PLANNING COMMISSION
Regular Meeting
Monday, May 22, 2023
6:00 PM
Christine Nuernberg Hall

Agenda

TO: Planning Commission
FROM: JAC ZADER, ASSISTANT DIRECTOR COMMUNITY DEVELOPMENT
DATE: May 22, 2023
SUBJECT: Jilly's Car Wash. The applicant is seeking master sign plan approval for the property located at 10829 N. Port Washington Road.

TO: Planning Commission
FROM: KIM TOLLEFSON, DIRECTOR OF COMMUNITY DEVELOPMENT
DATE: May 22, 2023
SUBJECT: Aurora Healthcare. The applicant is seeking building and site plan amendment approval to allow for a 2,700 sq. ft. addition for the property located at 6425 W, Mequon Road. REMOVE FROM TABLE

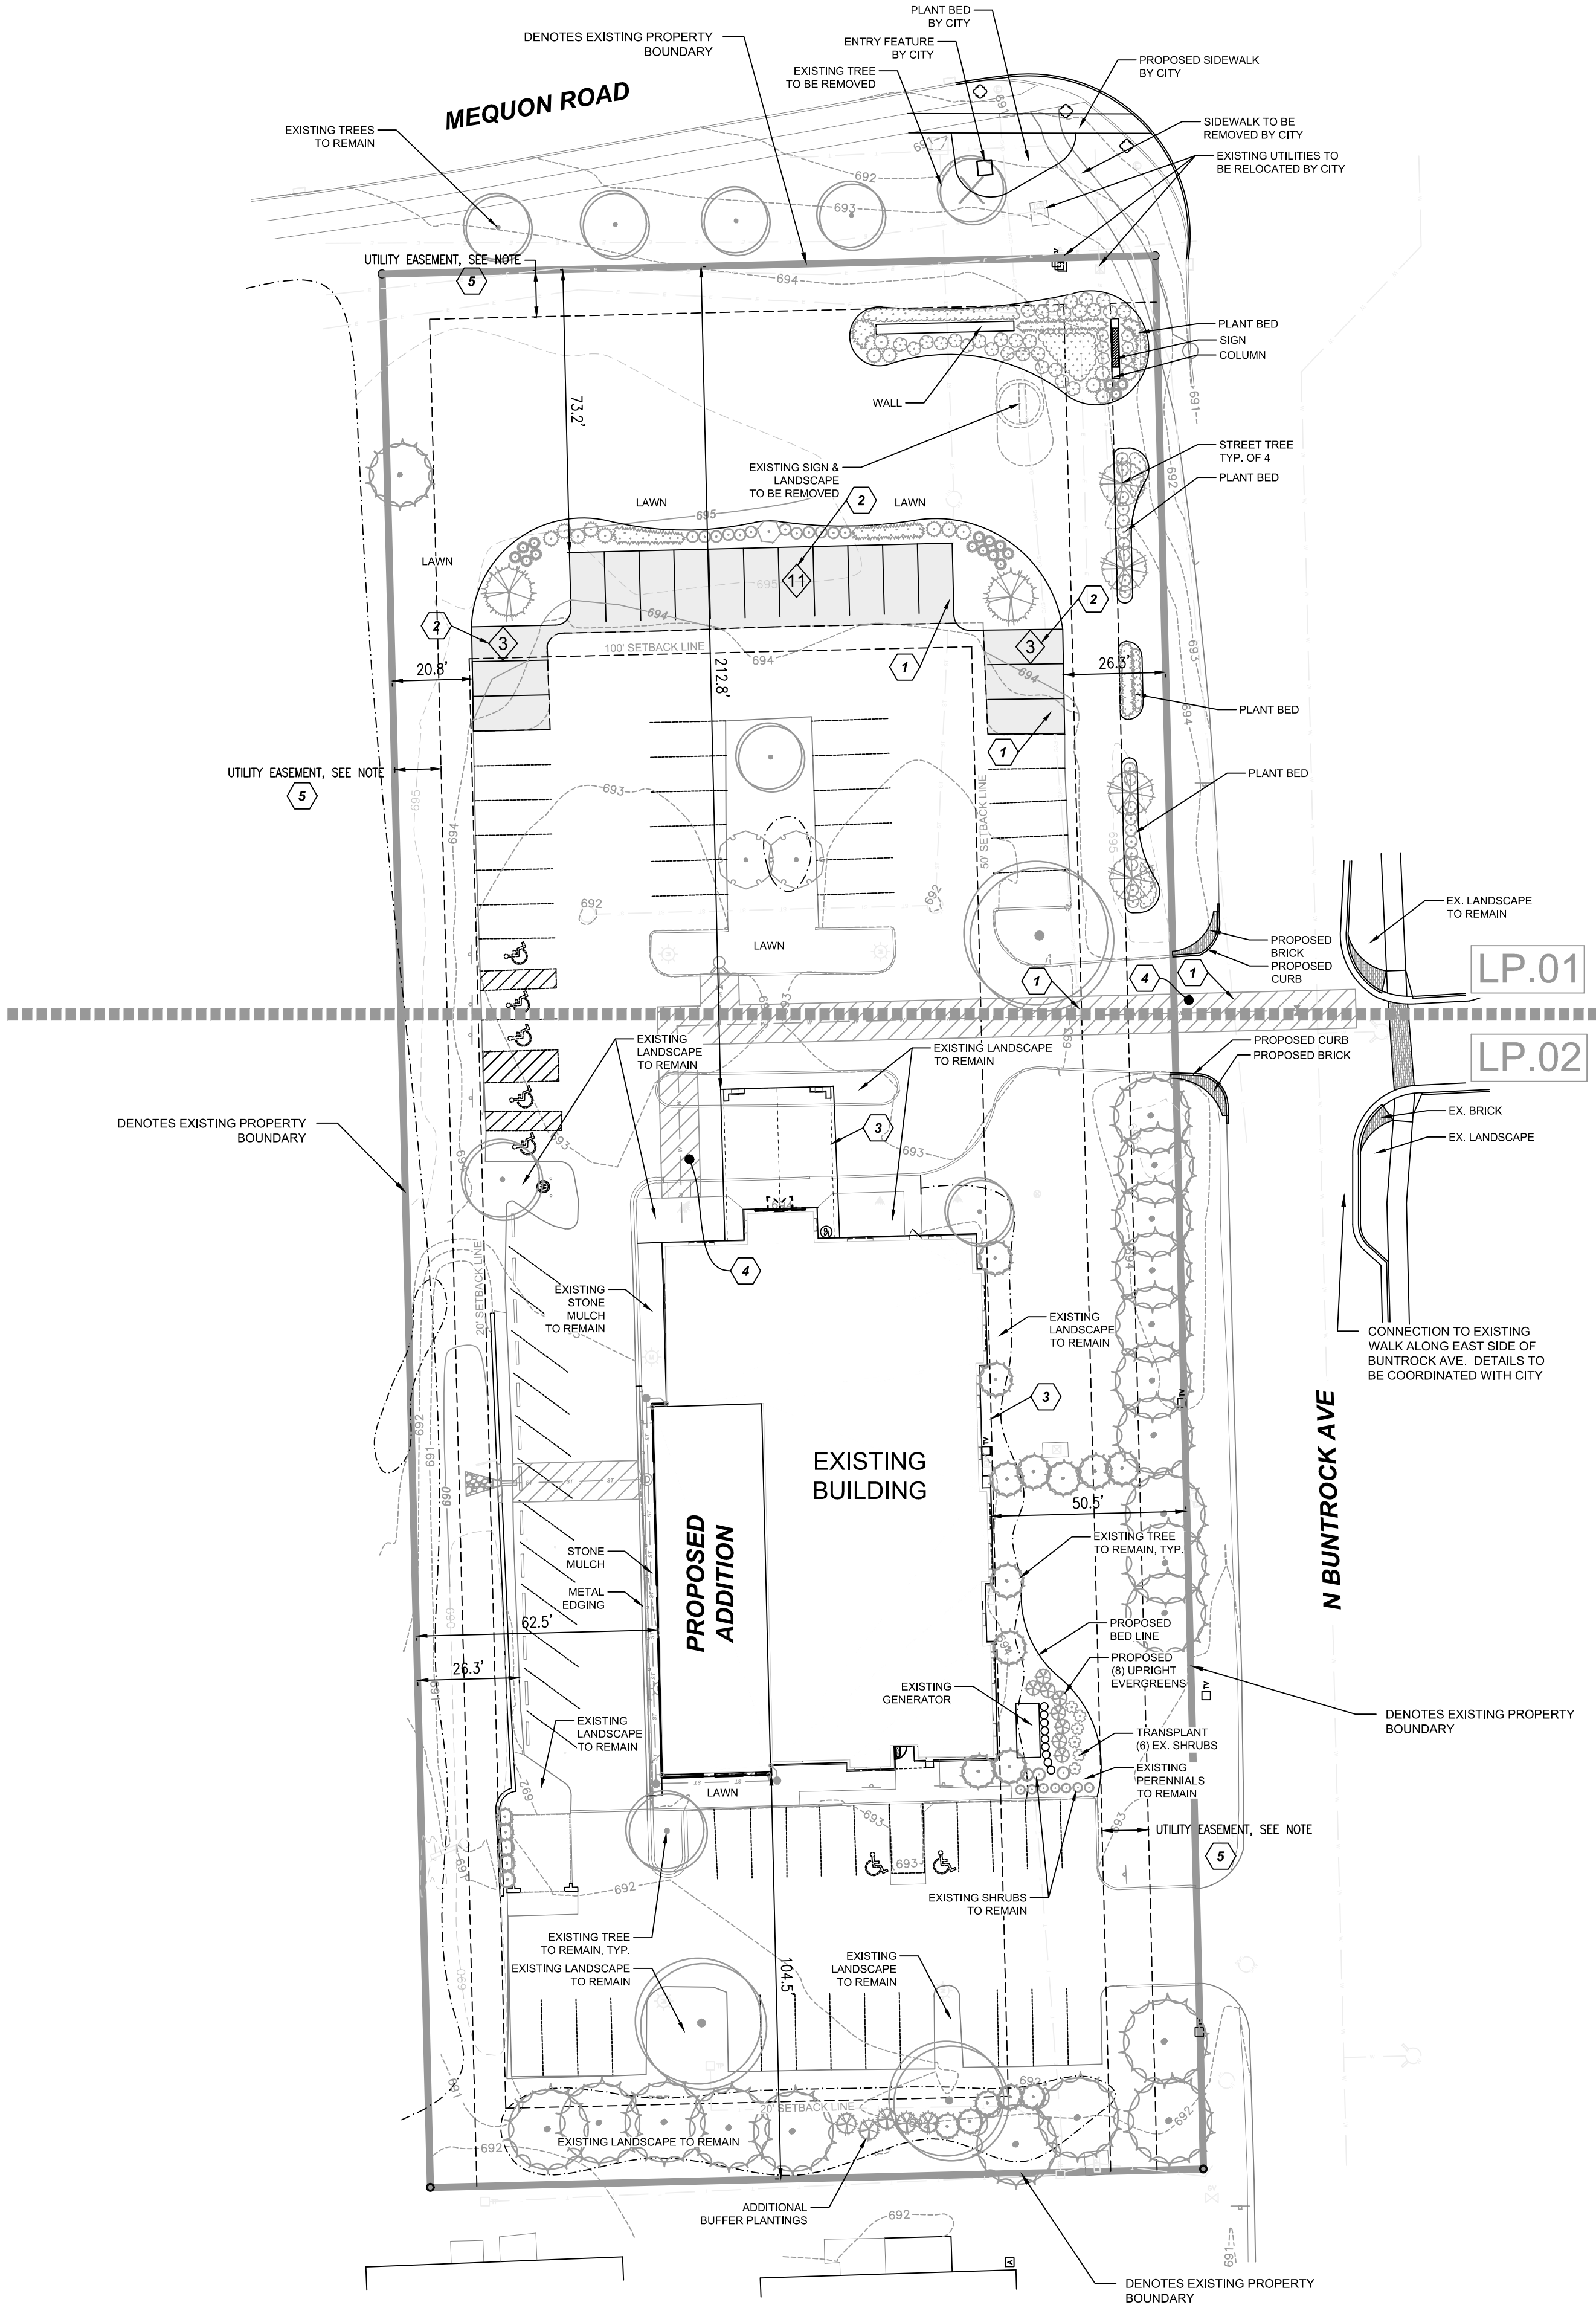
Staff recommends two additional amendments for the site plan approval. First, the City altered its location for Town Center gateway signage to accommodate the proposed Aurora sign and seat wall. Staff believe it is important to anchor the corner of this intersection, even with no building present, similar to the approach at the Outpost Natural Foods site. These additions create a completely different experience and comfort level for pedestrians. The City's proposed sign at this corner would impair sight lines to the Aurora sign and create a lot of features within a small area at the intersection. Therefore, staff and the applicant have agreed to an easement dedicated to the City at the northwest corner of the Aurora of no greater than 20x20 – outside of the utility easement, for the Town Center sign and an entryway landscaping bed. The final location and easement for construction, access and maintenance of the area will be addressed and the City will be responsible for maintenance. Second, the planning efforts for this section of the neighborhood include access easements that run east / west to provide access across adjacent parcels and out to Mequon Trail and Buntrock Avenue. These parcels are all deep and expect to develop with residential uses to the rear and commercial to the front. Alternative access points to the side streets have been deemed necessary. Staff conditions the approval of a reservation /easement, with effective dates associated with timing of adjacent development and redevelopment of this site for access at the south end of the Aurora site.

Staff expect the seat wall to not be less than 3'6" in height and treated with stone and a stone cap. In addition, ornamental trees shall be added to the backside of the sign wall to add depth, height and massing at the corner of the intersection.

1. Staff review and final approval of site, lighting, landscaping, building and sign plans. All plans shall be submitted within 90 days of Planning Commission approval, or the project shall return to Planning Commission.

5. The seat walls shall not be less than 3'6" in height and treated with stone and a stone cap. In addition, ornamental trees shall be added to the backside of the sign wall to add depth, height, and massing at the corner of the intersection.

LANDSCAPE PLAN
NORTH

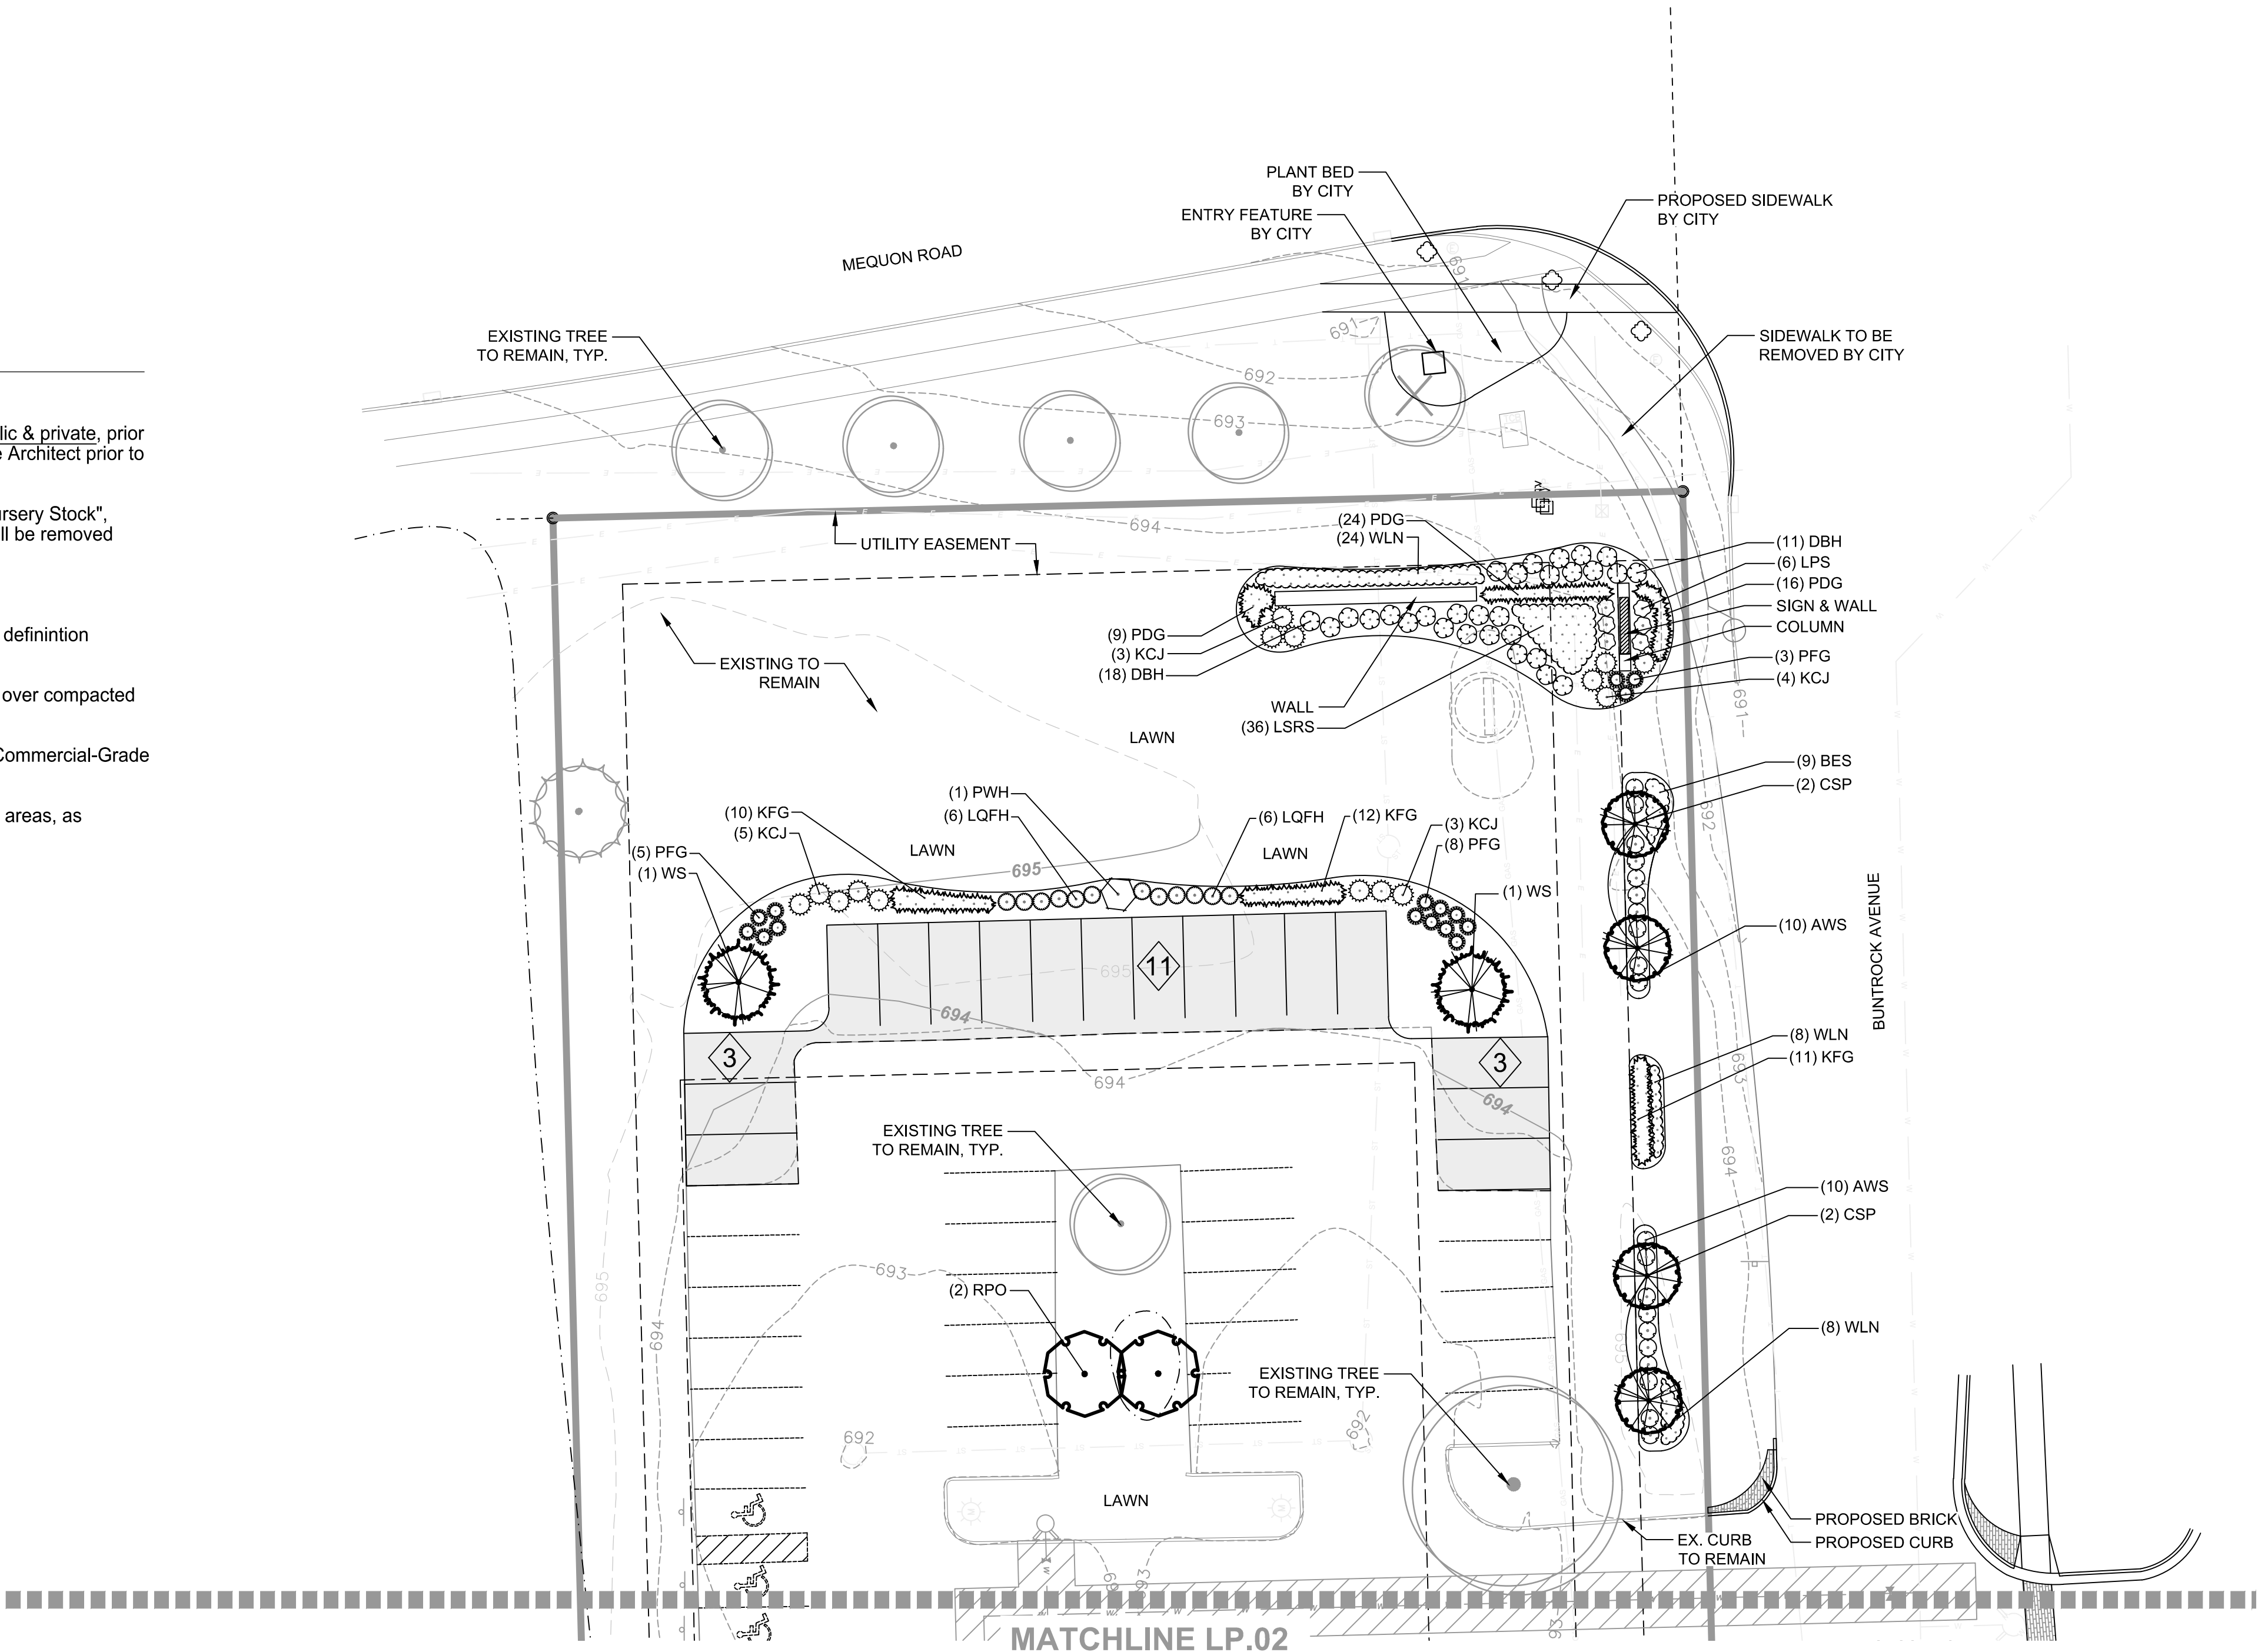
The landscape plan will require some modifications of species to match TC species selections, including within the sign wall beds. The landscape beds for the sign and walls shall be designed to provide continuity to the City planned landscaped bed which will screen transformers located

in the right-of-way. Staff recommends the plan be reviewed for final approval by the city's landscape architect.

2. The landscape plan will require some modifications of species to match TC species selections, including within the sign wall beds. The landscape beds for the sign and walls shall be designed to provide continuity to the City planned landscaped bed which will screen transformers located in the right-of-way. Ornamental trees shall be added to the Mequon Road street frontage on private property.

3. Landscaping plans shall be reviewed for final approval by the city's landscape architect for compliance with the technical standards of the code.
4. The light fixtures within the parking lot shall have a black base and fixture.
